MARCH 3, 2026

PLANNING COMMISSION MEETING

SPRINGDALE PLANNING COMMISSION
201 SPRING STREET
5:00 P.M.
MARCH 3, 2026
TENTATIVE AGENDA

SANITARY SEWER PLAN BENEDETTO PHASE 3 SPRINGDALE, ARKANSAS

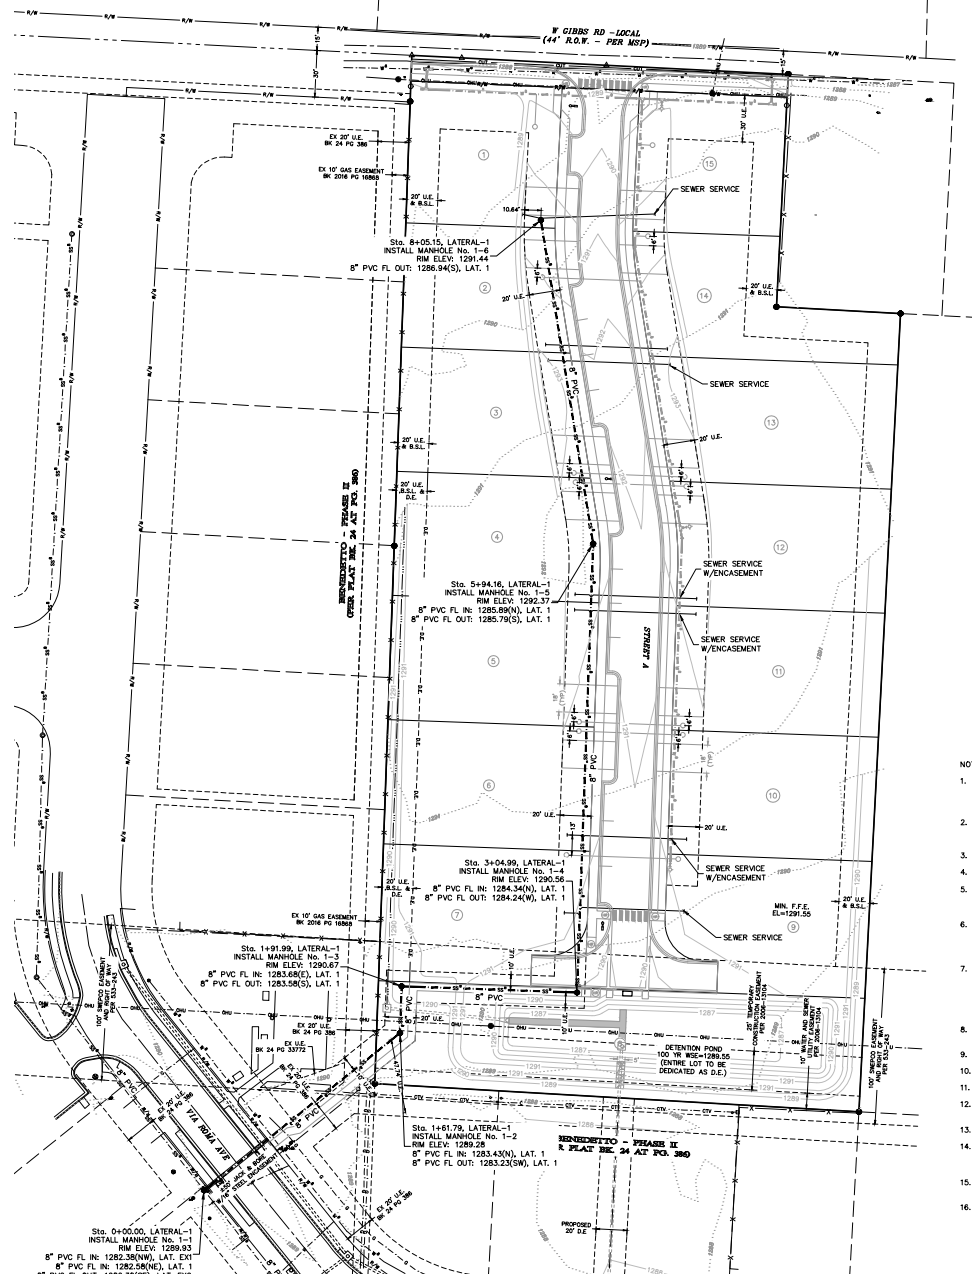
9. Display total acreage under site information.
10. Update Lot Information to include the common area also identified as HOA lot 8, update lot 8 label on preliminary plat sheet.
11. Provide a crosswalk to the southern crossing which leads to the amenities.

- All street sections shall be determined by formal design with geotechnical analysis. Submit detailed plans and Geotech report prior to construction.
- Smooth out 90 degree turn in the sidewalk

- Subdivisions must stub in all 4 cardinal directions
 - o Waiver requested
 - o South connection is important for neighborhood connectivity and overall community feel. It would give direct vehicular access to subdivision amenities.
 - o At least need to provide a 15' alley access to Via Roma and then hammerhead can be eliminated.
